SEPTEMBER 16, 2022

ADDENDUM NO. 02 to the plans and specifications for the MACOMB COUNTY JAIL, VARIOUS PROJECTS PROPOSAL A, B AND C, MT. CLEMENS, MI, Architect's Project No. 221958, dated August 26, 2022

**PROPOSAL A-SANITARY REPLACEMENT**

**PROPOSAL B-BARRIER MESH/SCREEN**

**ELEVENTH FLOOR PLAN**  
SCALE: 1/32"=1'-0"  
**11,938 S.F.**

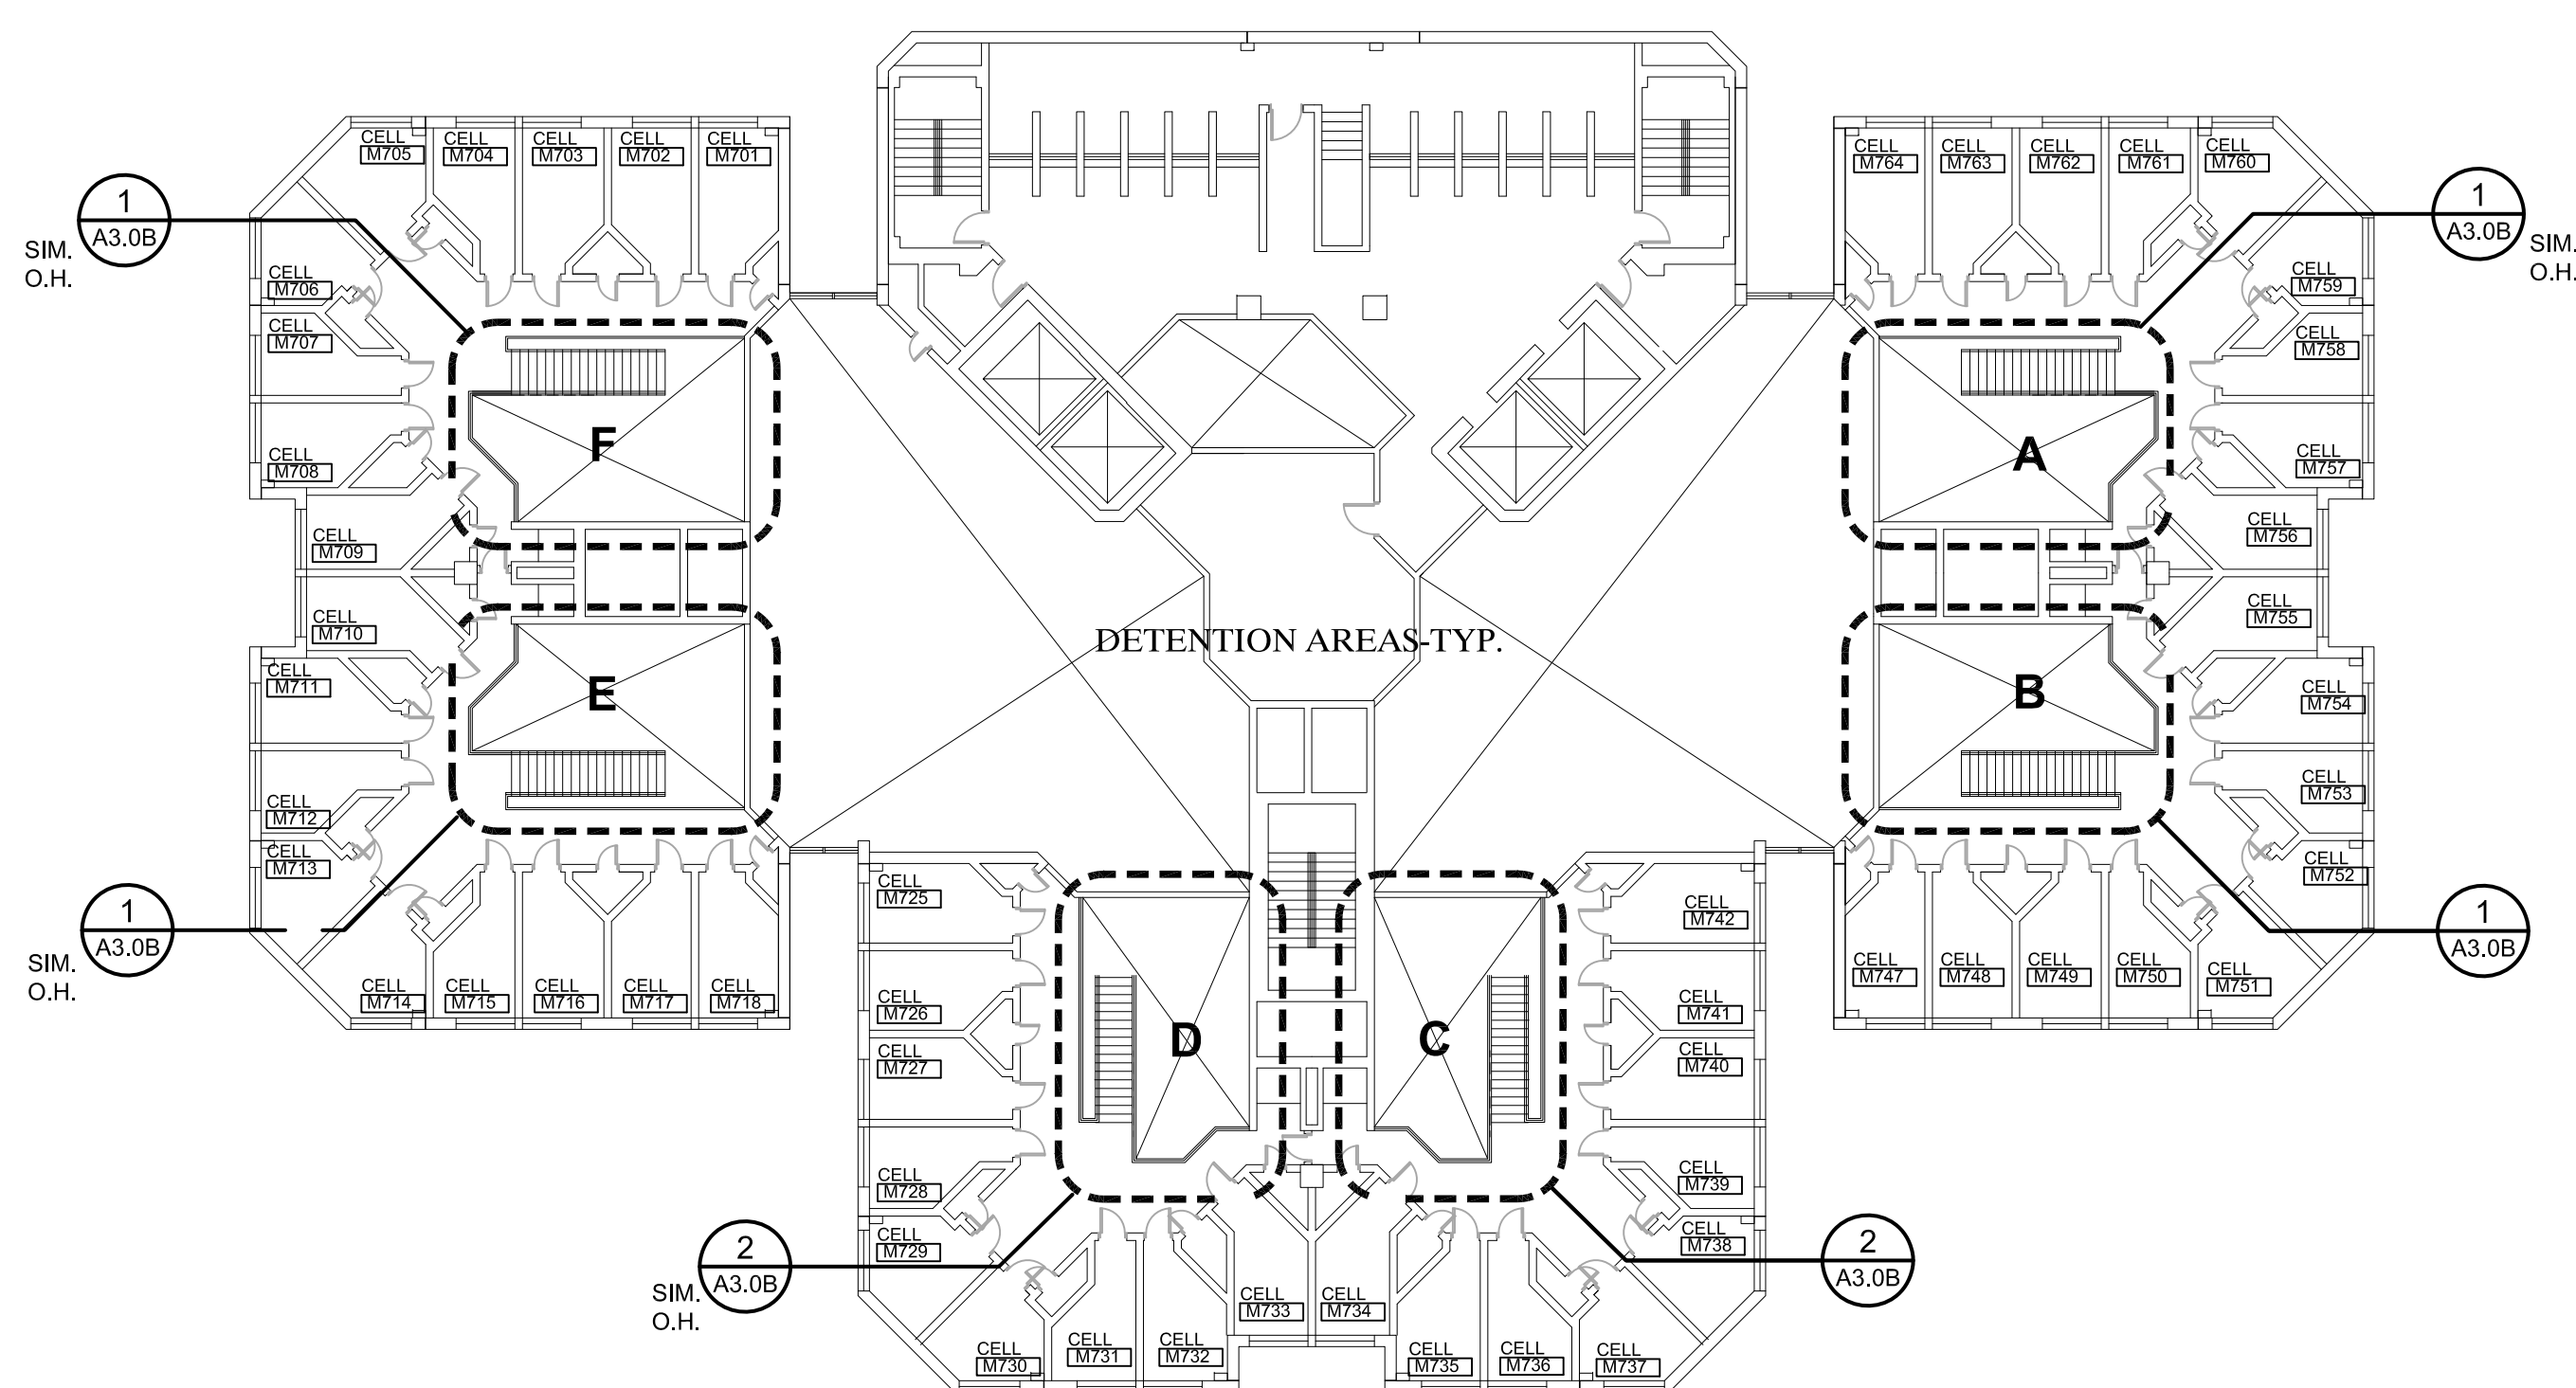
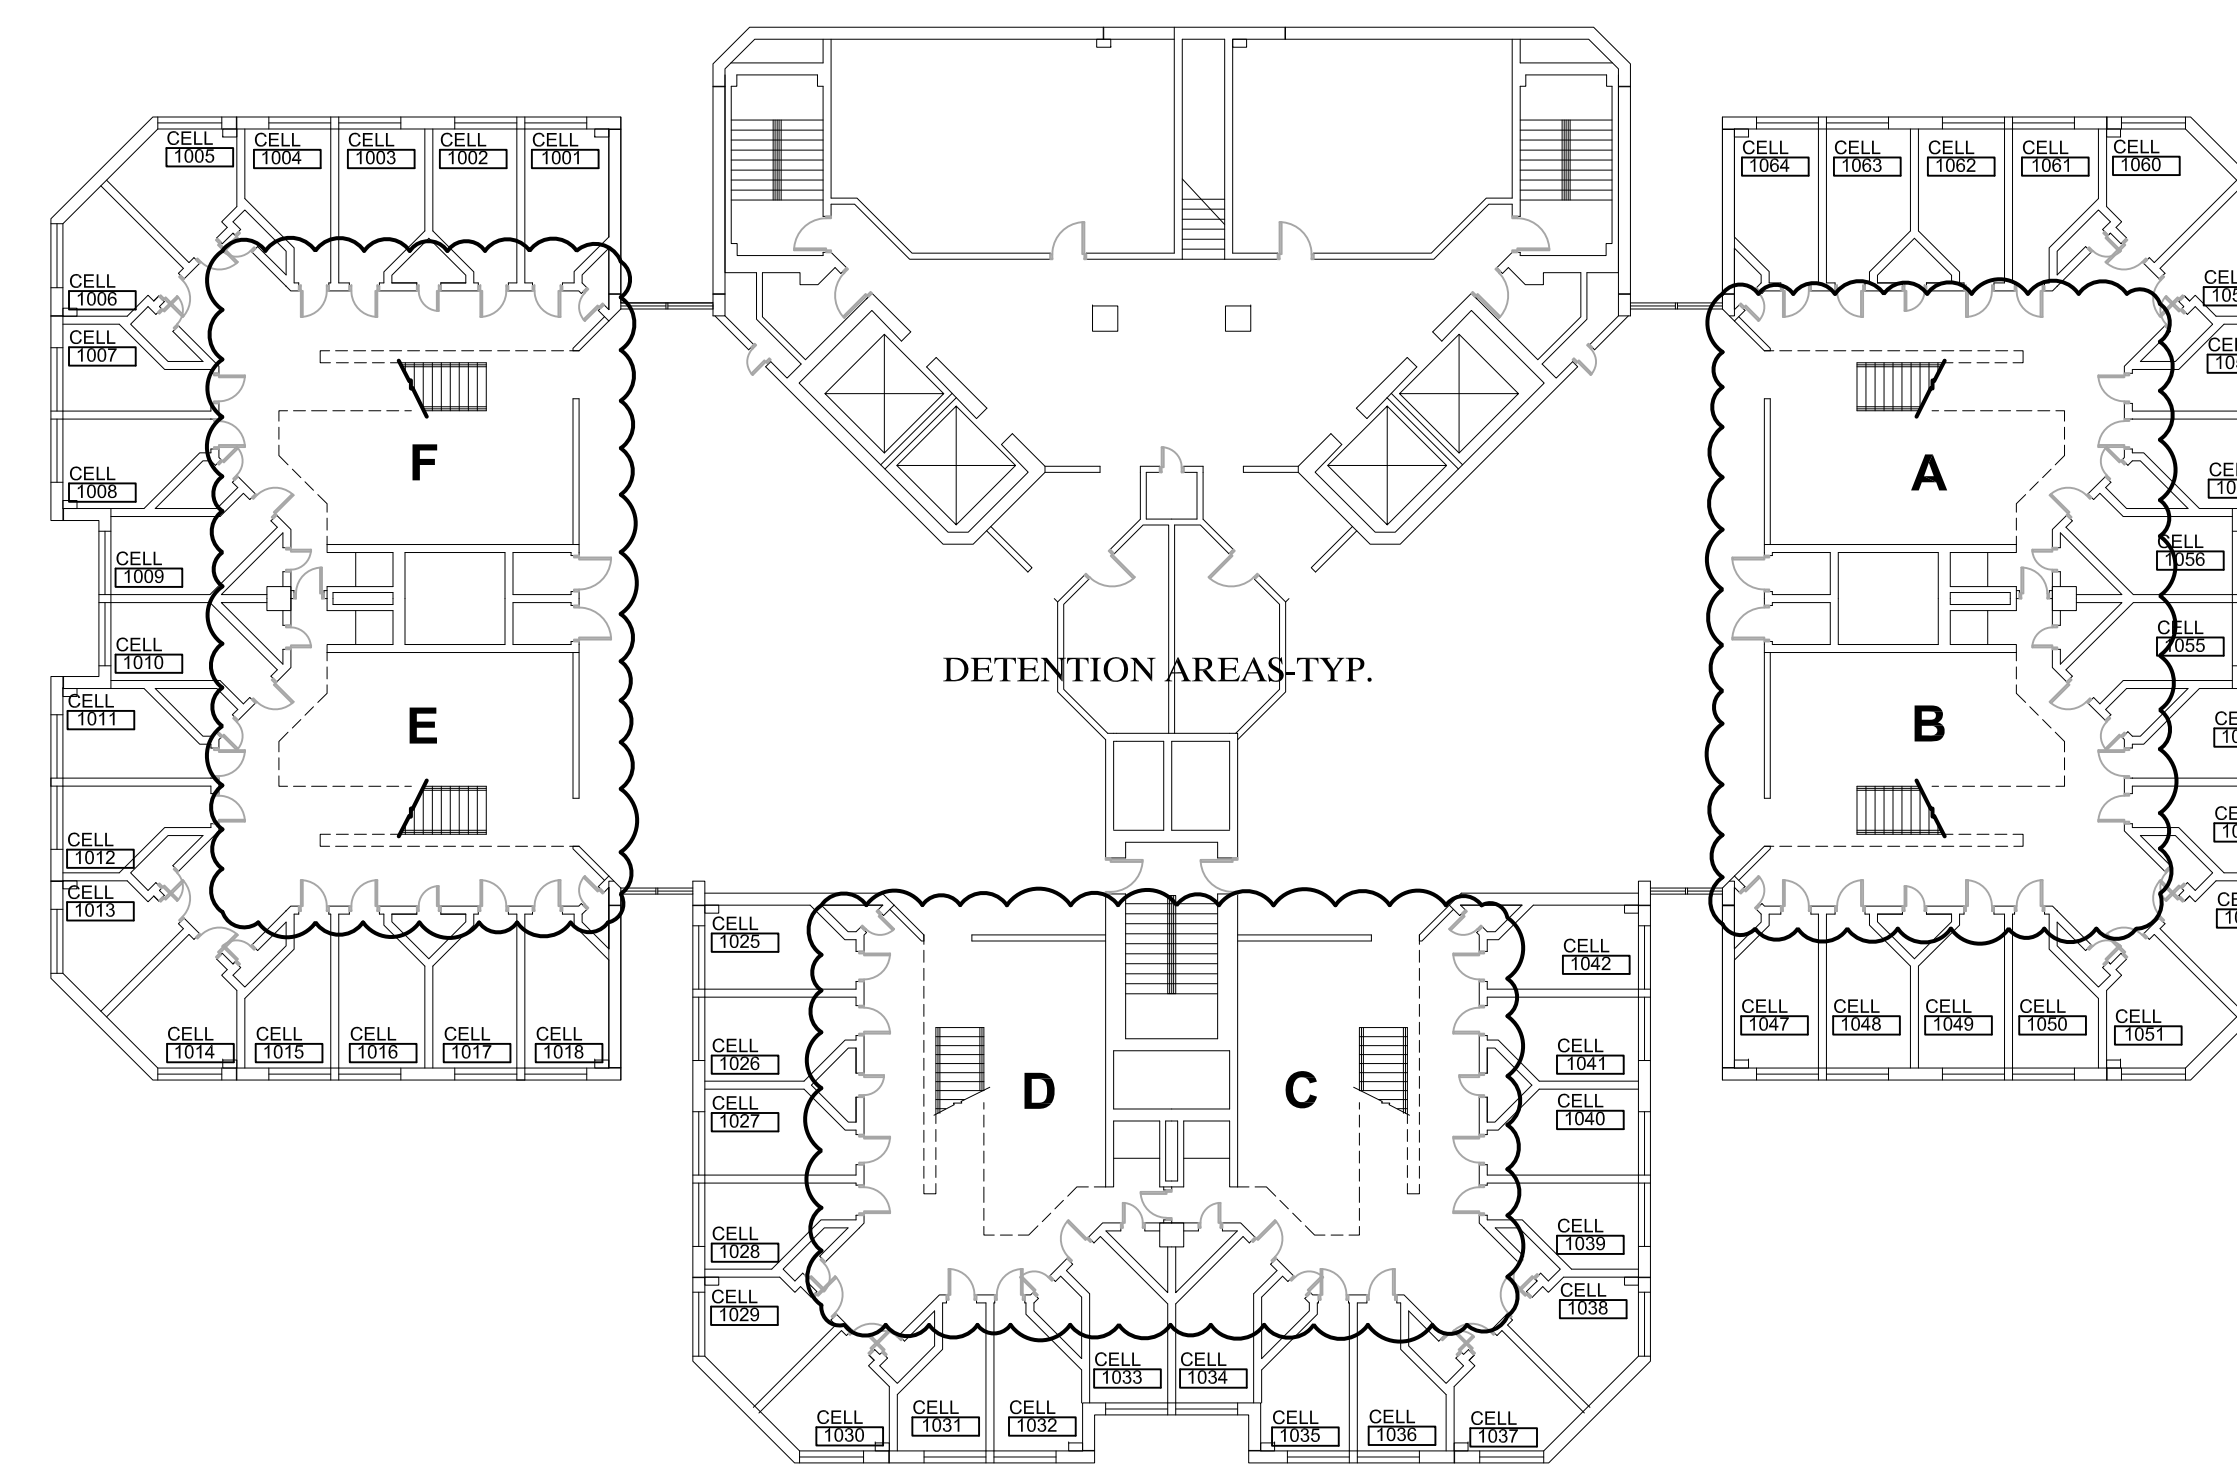
- ITEM NO. A4:** Refer to sheet A0.4A (re-issued):
1. Removed callouts 1 and 2 from the floors 8 and 10.
